35/130-03A 4105 Stanford Street
(Horton House, Master Plan Site 35/130)

RE: Changes to approved HAWP # 318960
4105 Stanford Street, Chevy Chase (Horton House) Master Plan site # 35/130

RE: Changes to approved HAWP # 318960
4105 Stanford Street, Chevy Chase (Horton House) Master Plan site # 35/130

Attached please find an email describing proposed changes to a previously-approved HAWP for 4105 Stanford Street (Horton House) in Chevy Chase as well as the approved and proposed elevations.

1. FIRST FLOOR PLAN
 A.2 SCALE: 1/4" = 1'-0"

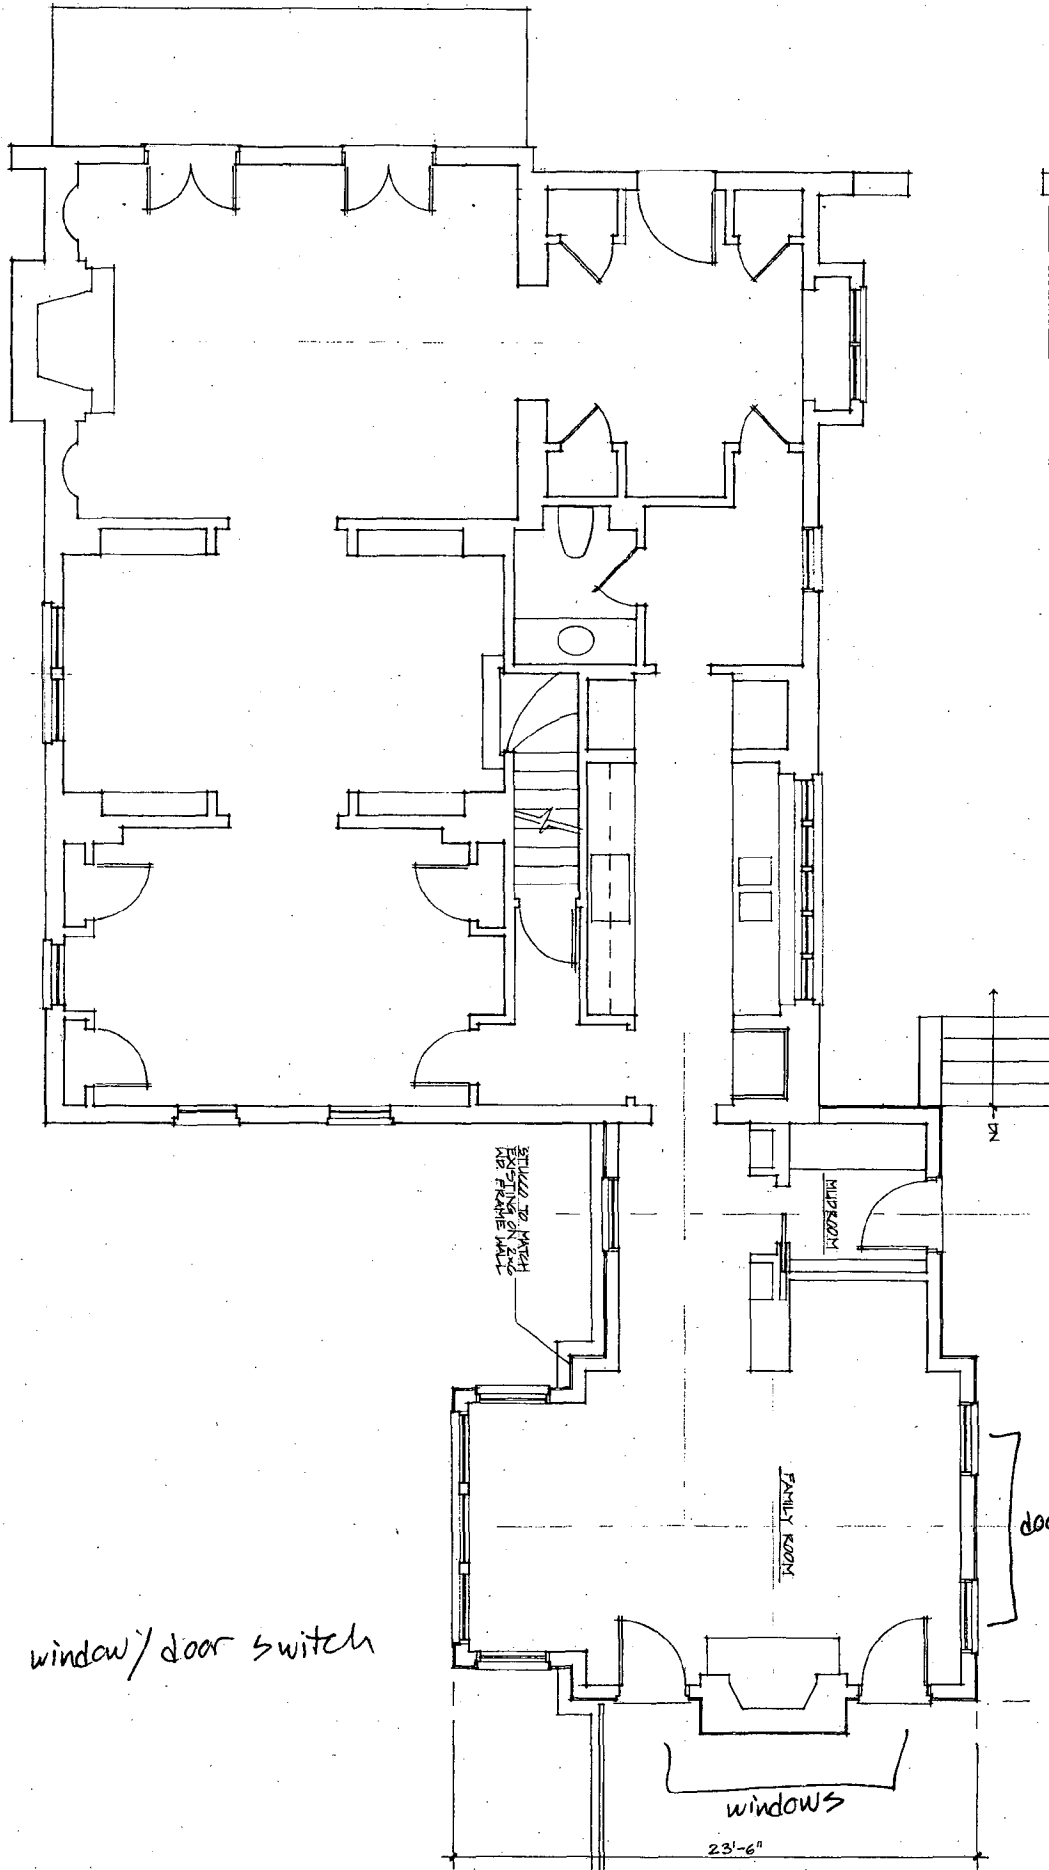
The applicant would like to flip the 2 doors and 2 windows at the rear and side of the new addition to the house. The windows and doors will be the exact same as approved, just in the reverse locations.

1. We are deleting the exterior stair from the upper terrace to the lower yard. This is somewhat based on cost, but also on our belief that we just don't need this stair.
2. We had proposed two 3'-0" wide doors from family room to rear terrace and two 3'-0" wide windows facing the neighboring house. We would like to reverse these – putting the two doors on the side and the two windows on the rear. This is based on knowing that we will have windows open often and doors open seldom – and not wanting open windows to neighbors side.

window/door switch

I am writing you this letter regarding an approved change to the above-referenced Historic Area Work Permit. The owners of the house would like to switch 2 windows on the west elevation with 2 doors on the rear elevation. As this change is minor and takes place in the new addition and does not affect the historic integrity of the resource, staff is approving this design modification.

The windows and doors are part of the new addition and are not visible from the street. Staff finds these changes approvable and would like HPC's approval for staff-level approval of these changes.

1 WEST ELEVATION
SCALE: 1/4" = 1'-0"

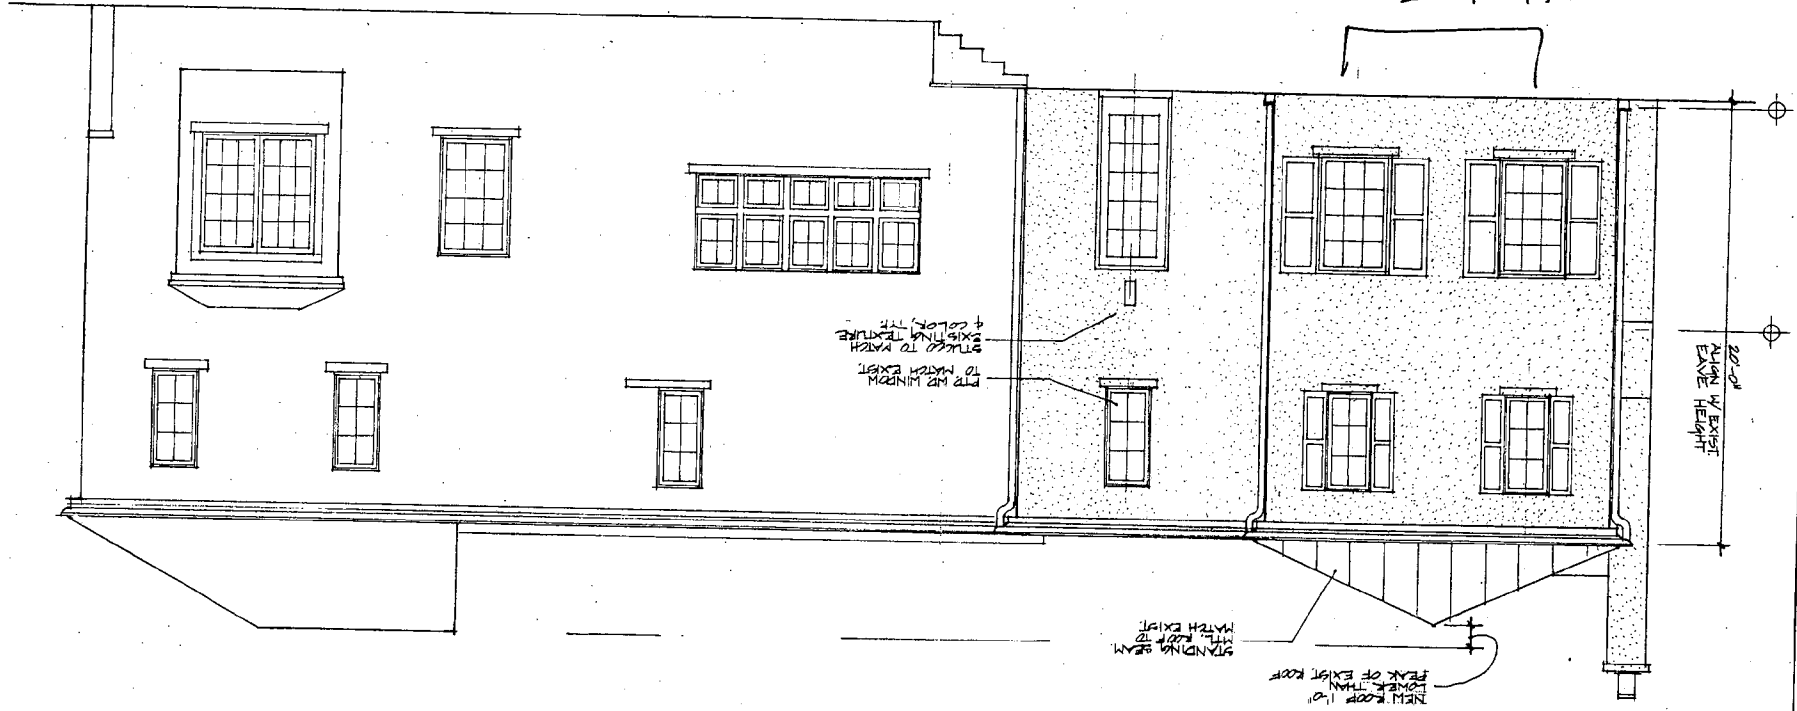
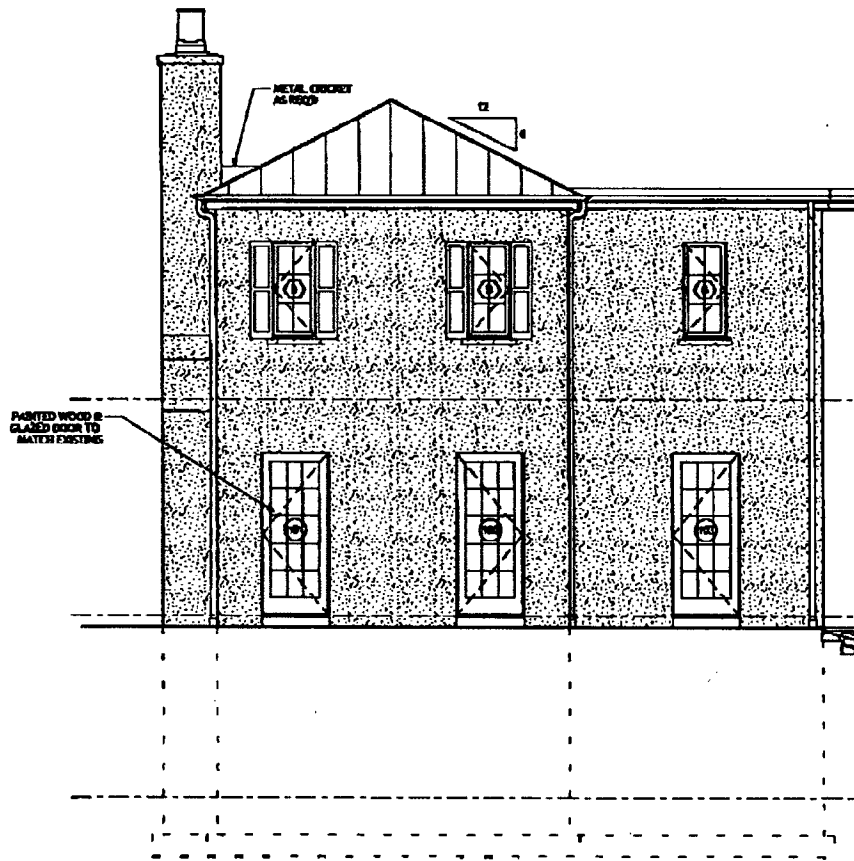
change to doors

① SITE PLAN
SP.1 SCALE: 1" = 10'-0"

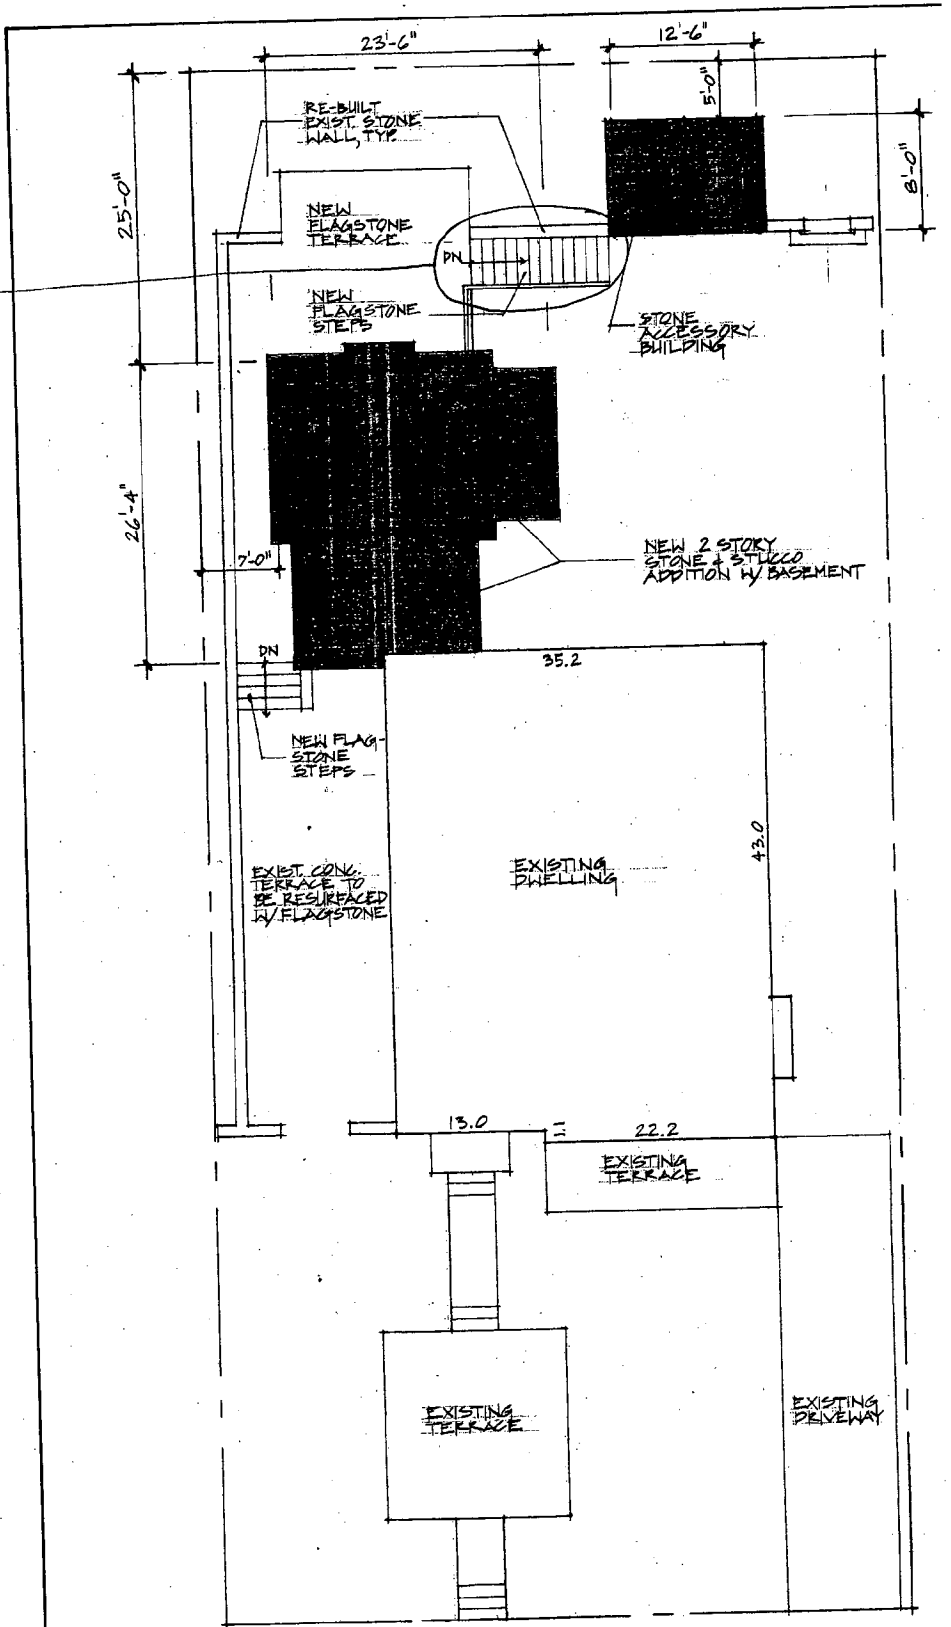
Additionally, they will not be building stairs from the terrace to the yard which had been approved.

No new stairs
